ENGINE EXHAUST SYSTEM

1792-01

OVERVIEW AND OPERATION PROCESS

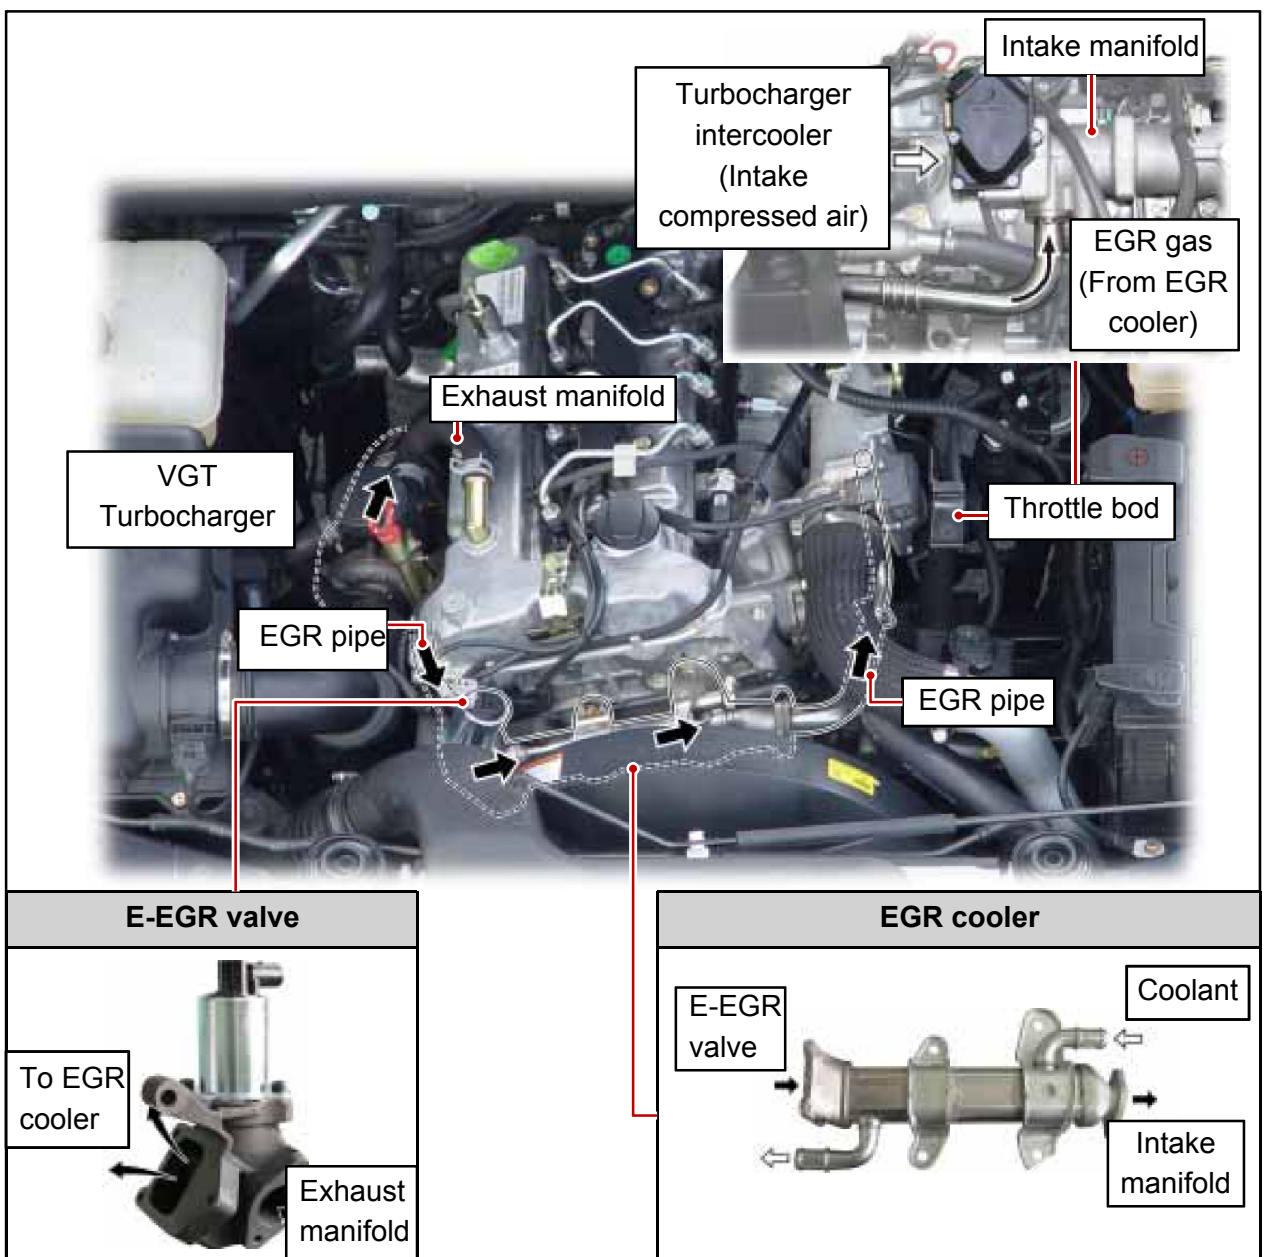
The components of the exhaust system for the D20DT (EURO4) engine have been changed as follows:

- ▶ E-EGR valve - Controlling the EGR valve electrically and sends the valve location signal to ECU (vacuum modulator control has been deleted)
- ▶ EGR cooler - Decreasing EGR gas (NOx) efficiently by cooling the EGR gas and let it flow to the intake pipe
